Ventura County Non-Coastal Zoning Ordinance

Piecemealing Truck Trip and Flaring –

Naumann Drill Pad, from Etting Road.

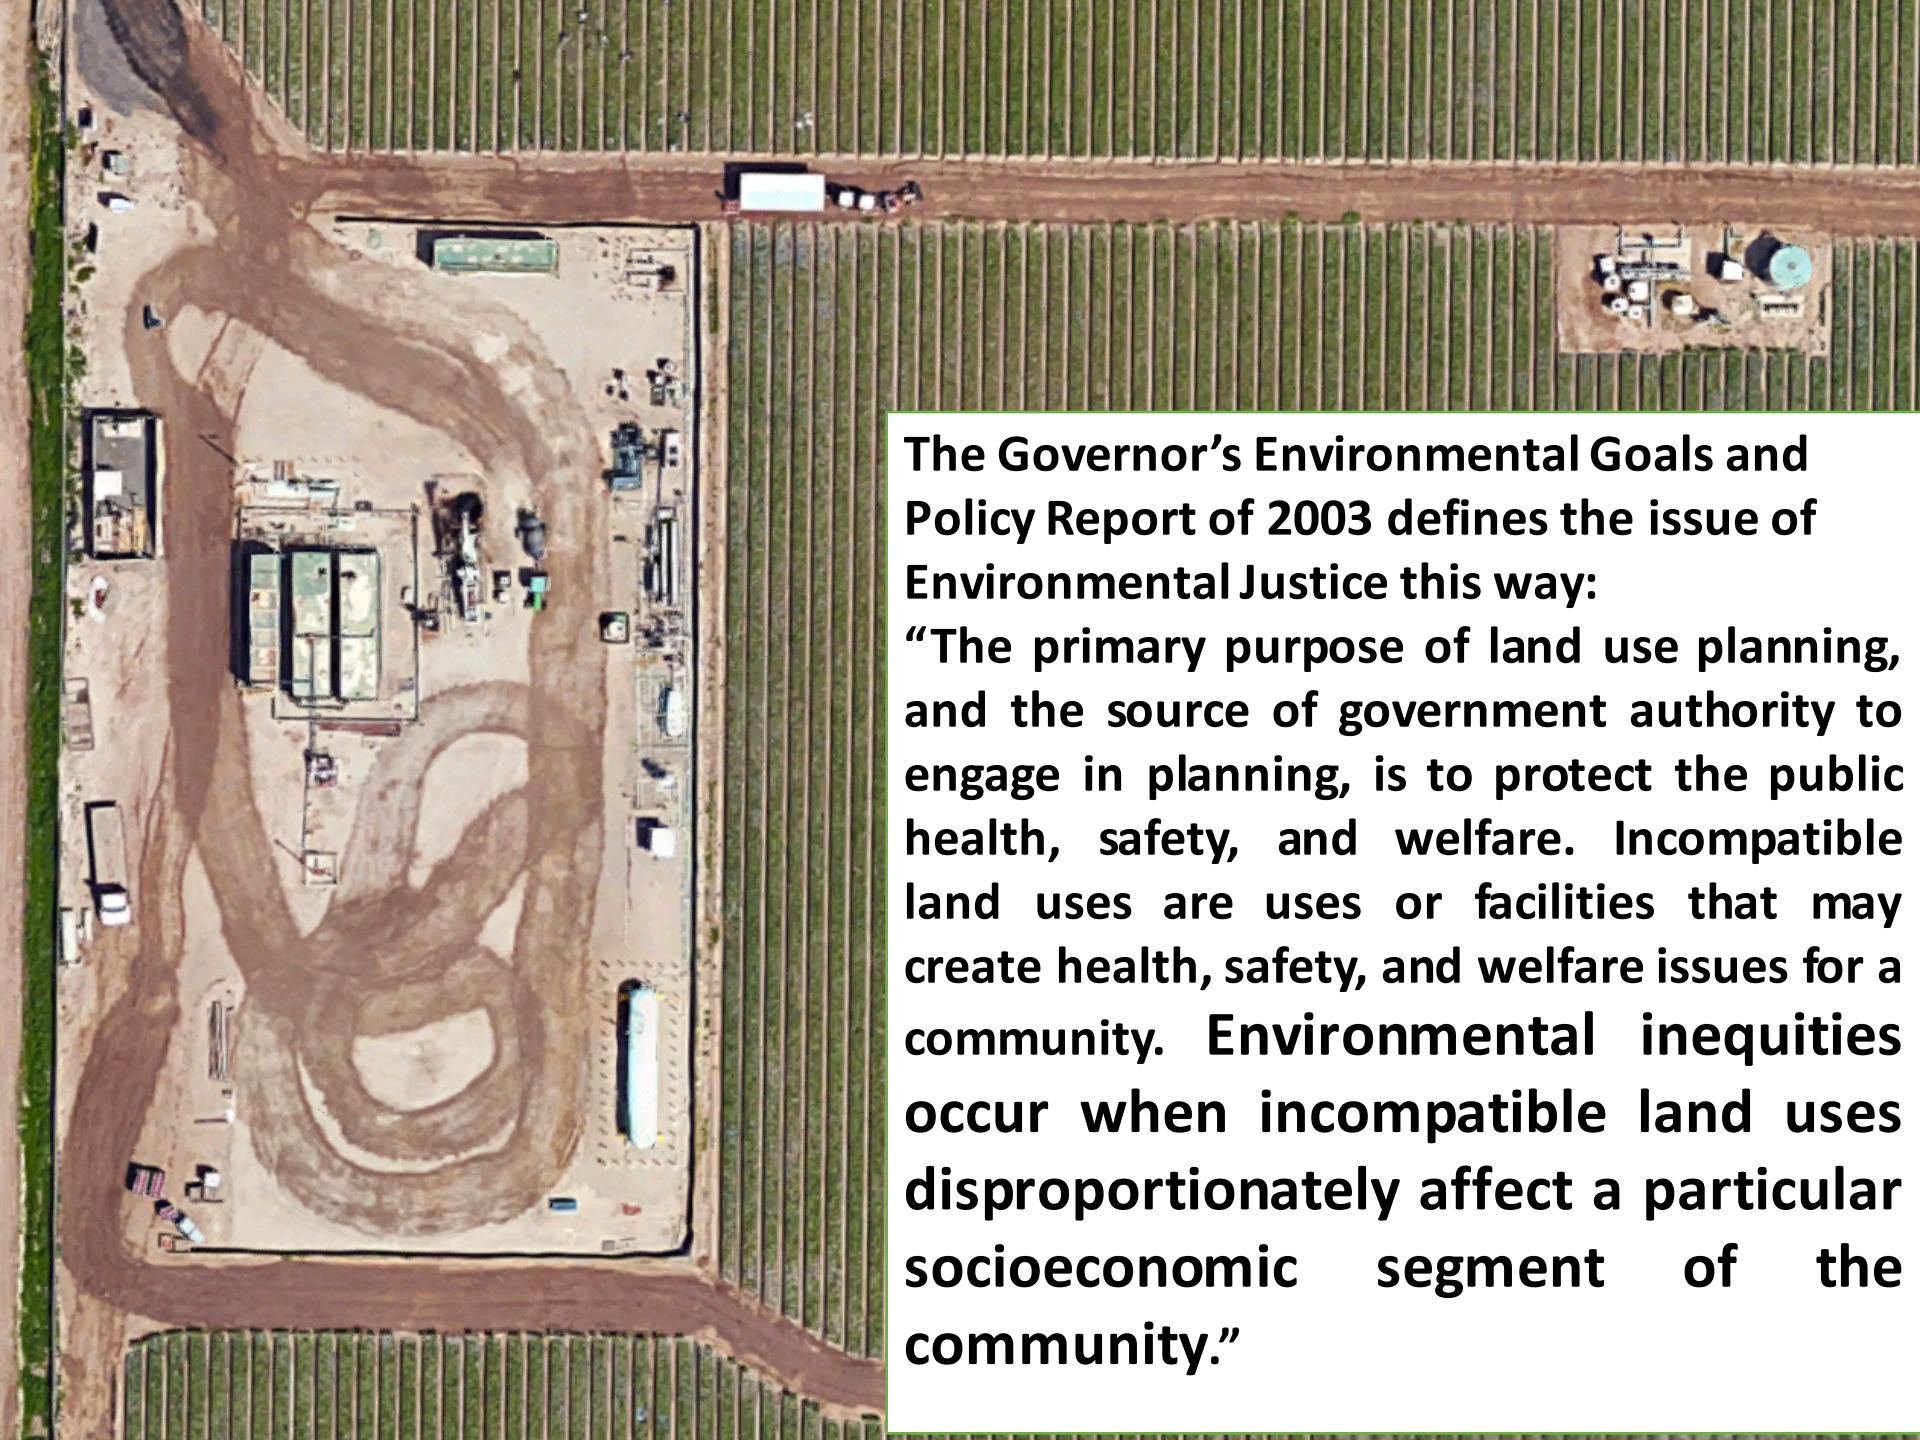
1. Alternative - Leave project as is, one well, facilities for one well, renewed permit. Suggest – flow monitor for continuous pilot and to track true emissions from unplanned “emergency” flaring, and perimeter monitor. Unannounced inspections when complaints received.
2. If project remains unchanged - wells added, and facility expanded to accommodate other drill pad/s –then Complete EIR that includes cumulative health impact assessment and Environmental Justice considerations related to Disadvantaged Community.

Rosenmund Drill Site

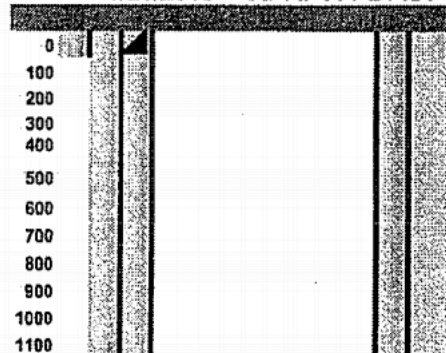
- Without complete information Ventura County agencies and public cannot know the true impacts of land use decisions - and any impacts cannot be properly mitigated.

- Segmentation or “piecemealing” of the project
- Lack of analysis of cumulative impacts including impacts to health.
- Lack of Environmental Justice considerations.
